## Hume Coal Project

# Response to reviews of the Hume Coal Project by Galvin and Associates, and Professor Ismet Canbulat

11 July 2018

Figure 5: Screen shot of Figure 13 from the Galvin and Associates review

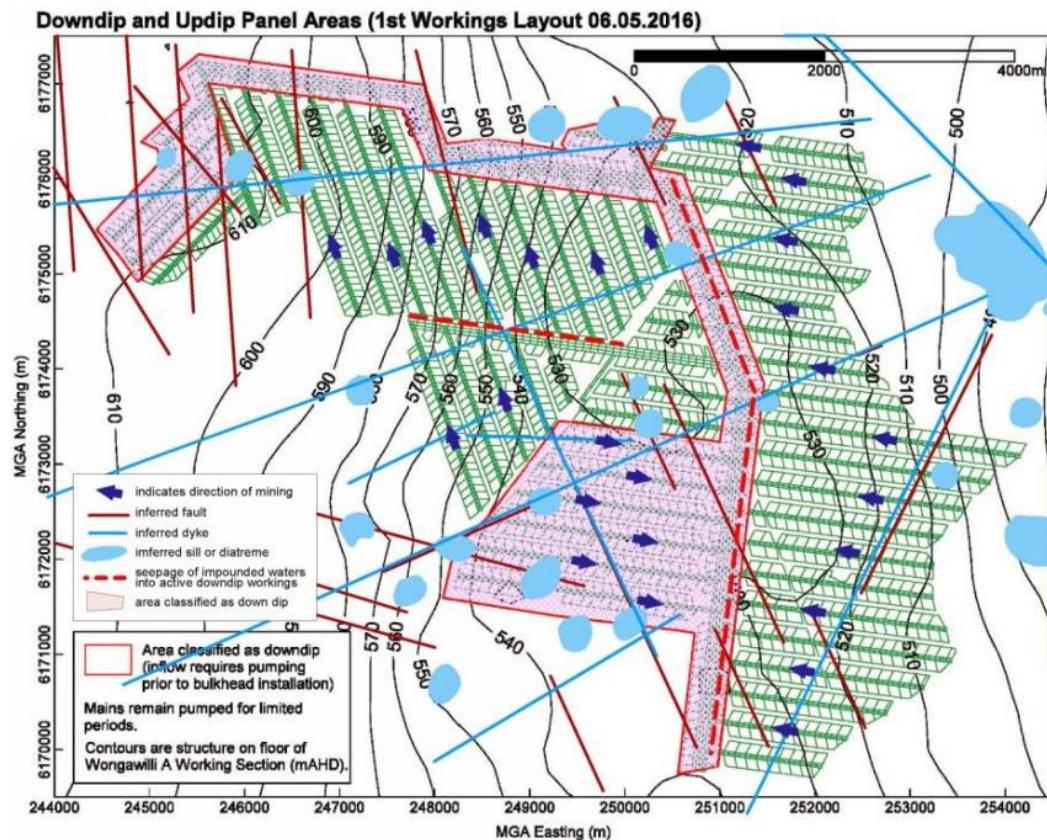
The Galvin and Associates review provides the figure below in the context of a discussion of potential seepage of impounded waters. Ideally this figure should have been referenced and the discussion should have made clear what aspects of the figure were modified from its original form in the EIS, because it contains some key inaccuracies. It is understood that the error will be corrected in subsequent reports or responses to Hume Coal.

Figure 6: Subsidence profiles for increasing number of panels from the Canbulat report with superimposed mine geometry (after Canbulat, 2017, p. 24)

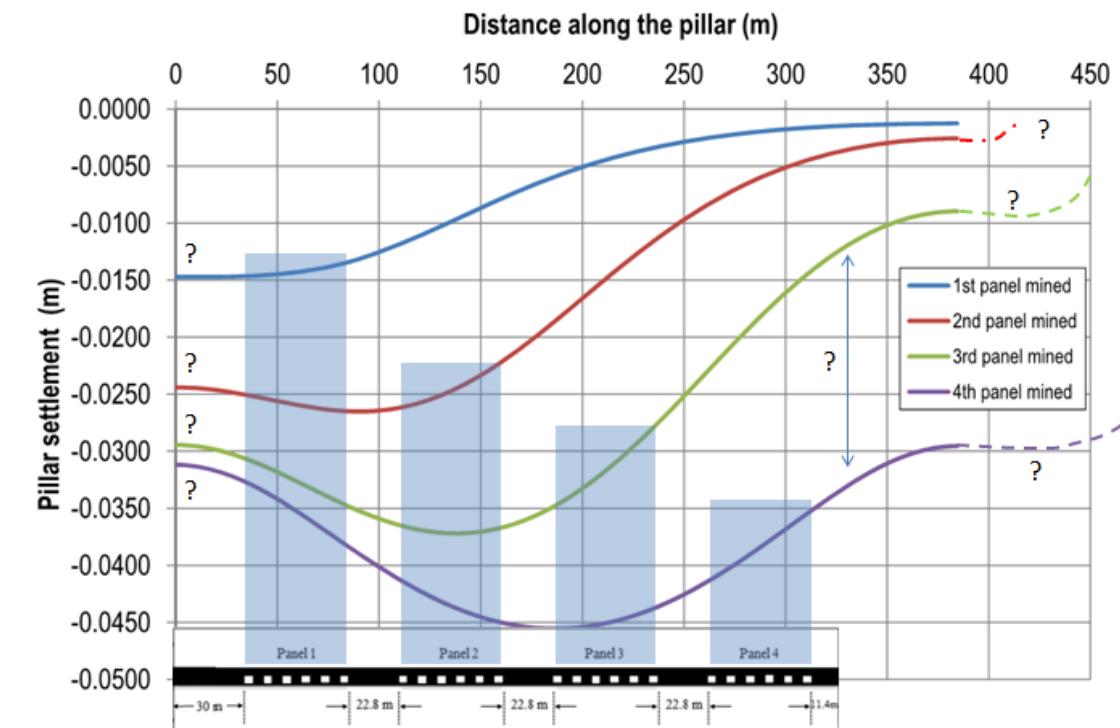
Also of note, a number of figures in the report are incorrectly labelled, either in the caption, chart titles or axes which makes the results difficult to interpret. In regards to Figure 21 of the Canbulat report, it must be first noted that the labelling of the x-axis is somewhat confusing as it refers to the "distance along the pillar" but it is not clear which pillar this refers to. It is possible that the composite figure presented below is an incorrect interpretation of the results presented in the Canbulat report, however even if this is the case, the results are just as anomalous, and the important key observations below still hold true.

A number of observations can be made in relation to Figure 6, presented below:

2. The fourth panel mined results in an increasing amount of incremental/differential subsidence with increasing distance from the edge of the mine void *over the solid coal* (right hand side of the model). See double ended arrow in Figure 6.

4. These asymptotic trends would require the profiles to bend in strange directions outside of the model boundaries in order to reach zero, as they should in such a simple model.  
Examples are shown in Figure 6 below using dashed lines accompanied by question marks.

**Figure 7: Subsidence profiles for varying depth from the Canbulat report with superimposed mine geometry (after Canbulat 2017, p. 24)**

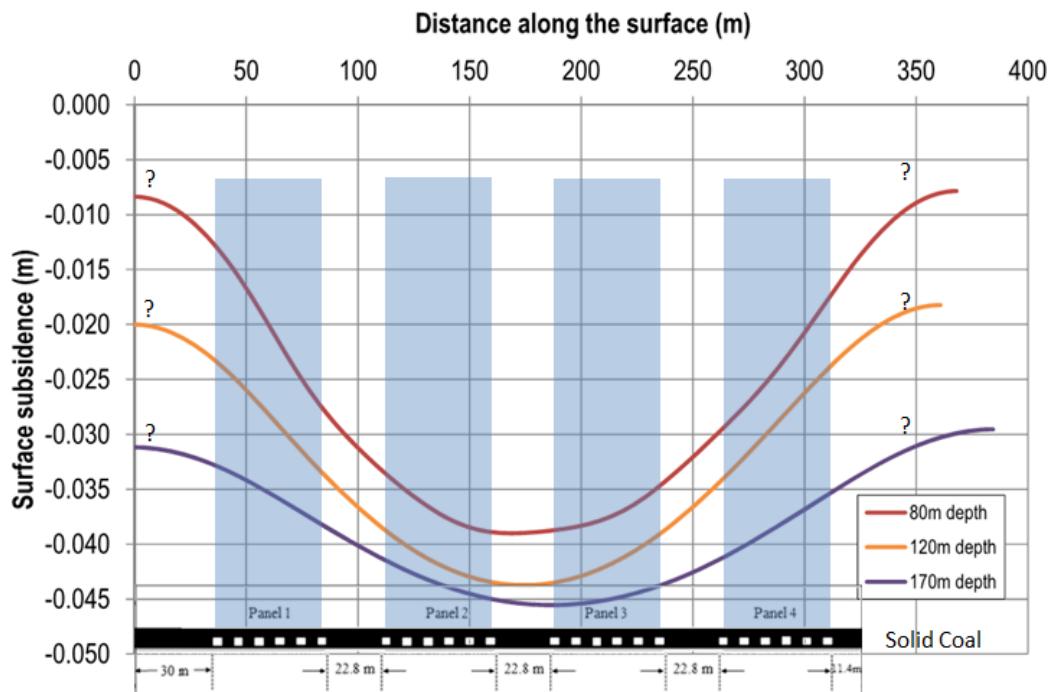
The following additional observations can be made in regard to Figure 7:

5. The non-zero error (the value of the asymptote for each 2D settlement profile) increases proportionally with increasing depth
6. The x-axis label on the original figure (Figure 22) in the Canbulat report is different to that of Figure 21 and now refers to “distance along the surface”.
7. The y axis now refers to “surface subsidence” rather than “pillar settlement”. These are two different things, as surface subsidence includes the effects of compression and dilation of the overlying and underlying rock.
8. The 170m depth profile appears to be consistent between Figures 21 and 22 in the Canbulat report, inferring that the x-axis and y-axis are incorrectly labelled in the earlier figures.

One potential explanation is that gravity loading has not been applied to the model prior to including mining excavations. This would result in immediate levels of surface settlement over solid (unmined) coal once gravity and the effects of mining are applied together. For example, in Figure 7 the non-zero error appears to be in direct proportion to depth, which would lend support to this explanation.

**Figure: Figure 8 from Galvin and Associates 2017, reproduced with clearly labelled axes (after Esterhuizen et al. 2010)**

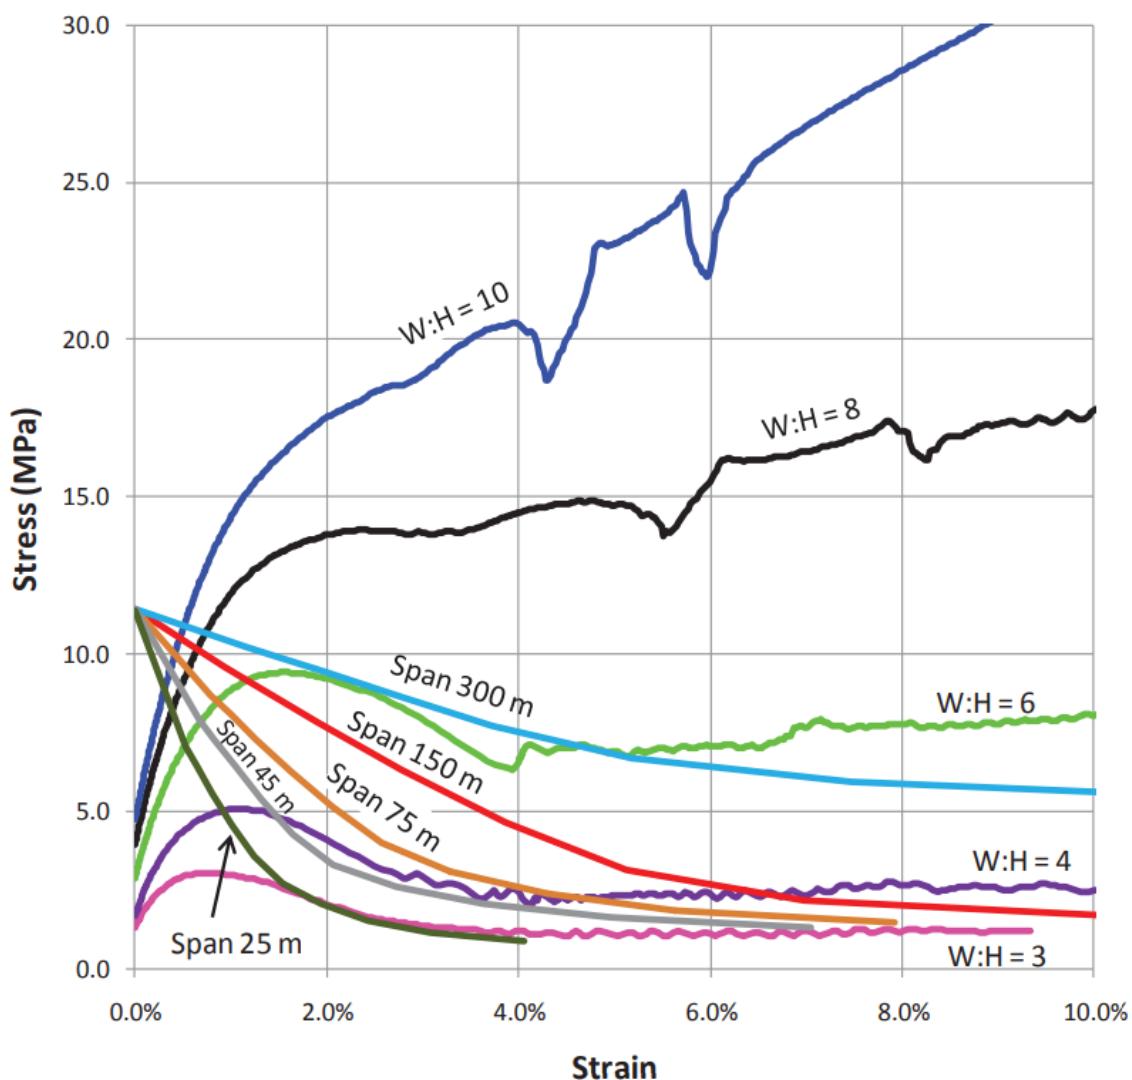
The figure referenced by Galvin and Associates has been reproduced below, with clearly labelled and legible axes.

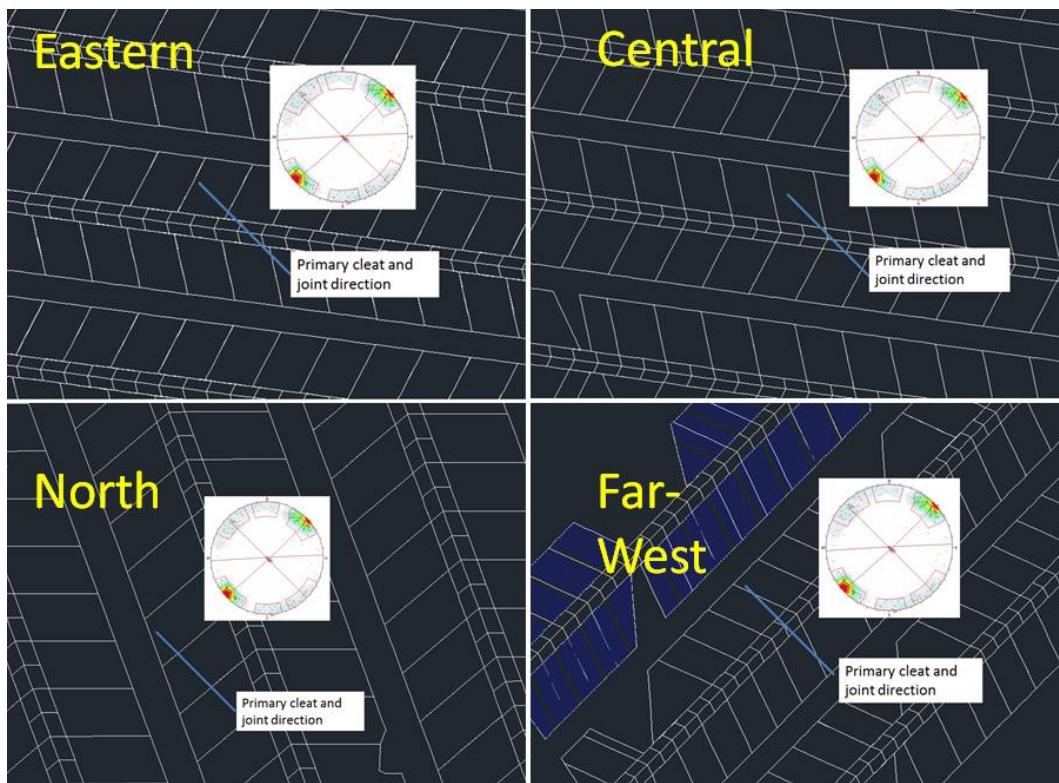
For example the W:H = 4 pillar has a peak support pressure of only 5MPa in the figure, whereas if this was the peak pillar strength, this should be in the order of 12-17MPa, depending on the strength index used and the pillar's oblongness in plan-view. This indicates that Esterhuizen has used an extraction ratio of about 2/3 at 450m depth, however, the Esterhuizen paper that Hume Coal has reviewed does not provide the actual extraction ratio used or the particulars of how it is calculated.

Therefore there is no credible way that this figure can be used to draw conclusions about the Hume Project, as the depth and extraction ratio range at Hume are completely different to the analysis in the Esterhuizen paper.
